Appendix A – Submissions Register – DHL South

1 Responses to Submissions

This section provides a detailed summary of the Applicant's response to the issues raised in submissions to SSD-70818708.

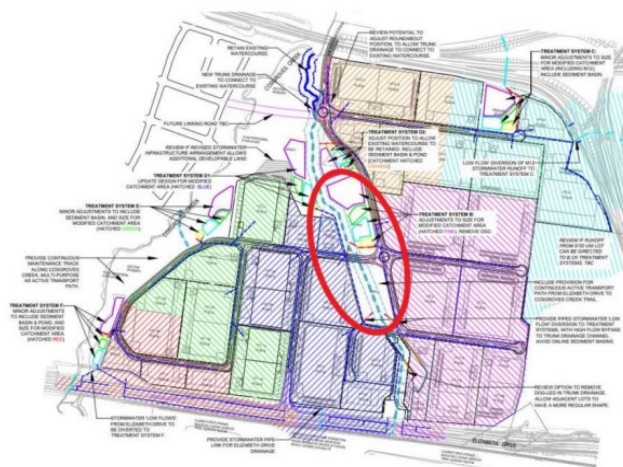
The current documents provided for SSD-70818708 do not demonstrate that the DHL warehouses meet the DCP requirements for stormwater quality targets and stormwater flow targets. Sydney Water requests that the construction of the DHL warehouses follows the general plan described in Concept Masterplan SSD-70316465 and includes all the specifications for stormwater conveyance and treatment through Basin B per the map below.
